Explanation

This document is the same as http://ieee802.org/3/bm/public/mmfdhac/meetings/jun12_14/802%203-95-TxVECImproved.pdf except the calculation is presented in a different way. The methods here and there are mathematically equivalent.

95.8.5 Transmitter vertical eye closure (TxVEC)

Figure 95–4—Illustration of the TxVEC measurement

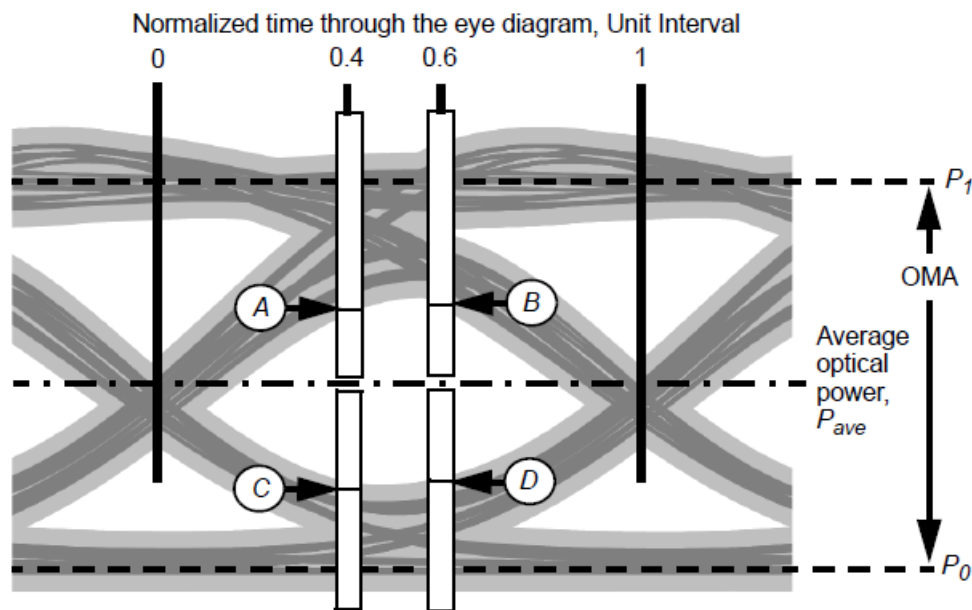
OMA is measured according to 95.8.4. ~~The power of the optical zeros (P_0) and the power of the optical ones (P_1) are recorded. Also the standard deviation of the noise of the oscilloscope, S , is found with no input optical signal and the same settings as used to capture the histograms described below.~~

Each histogram window has a width of 0.04 UI. Each histogram window has an inner height boundary which is set close to P_{ave} (so that no further samples would be captured by moving it closer to P_{ave}), and an outer height boundary which is set beyond the outer-most samples of the eye diagram, so that no further samples would be captured by increasing the outer boundary of the histogram. ~~Starting from the boundary of the histogram closest to the average optical power level, the optical power at which the cumulative distribution of each histogram equals the 0.005th percentile of the total number of samples for each histogram is recorded (these are the powers A , B , C , and D illustrated in Figure 95–4).~~

In Figure 95–4, delete the round labels and arrows A, B, C D. The values of P_1 and P_2 are not used in the calculation; they could be deleted if desired

~~TxVEC is defined as the largest of the four quantities given by Equation (95-1) to Equation (95-4):~~

The distributions of the two histograms on the left are each multiplied by Q functions, which represent an estimate of the probability of errors caused by each part of the histogram for the greatest tolerable noise that could be added by an optical channel and a receiver. The resulting distributions are integrated and each integral is divided by the integral of the distribution it was derived from, giving two BER probabilities. The Q function uses a standard deviation σ_L chosen so that the average of these two BER probabilities is 5×10^{-5} . Similarly, for the distributions of the two histograms on the right, a standard deviation σ_R is found.

$$\left(\int fu(y) Q((y - P_{ave})/\sigma_G) dy / \int fu(y) dy + \int fl(y) Q((P_{ave} - y)/\sigma_G) dy / \int fl(y) dy \right) / 2 = 5 \times 10^{-5} \tag{95-2}$$

$$R = \sqrt{N^2 + S^2 - M^2} \tag{95-3}$$

$$M = \sqrt{(0.0257 OMA)^2 + (0.01 P_{ave})^2} \tag{95-4}$$

$$TxVEC = 10 \log_{10}(OMA / (2 \times 3.8906 R)) \tag{95-5}$$
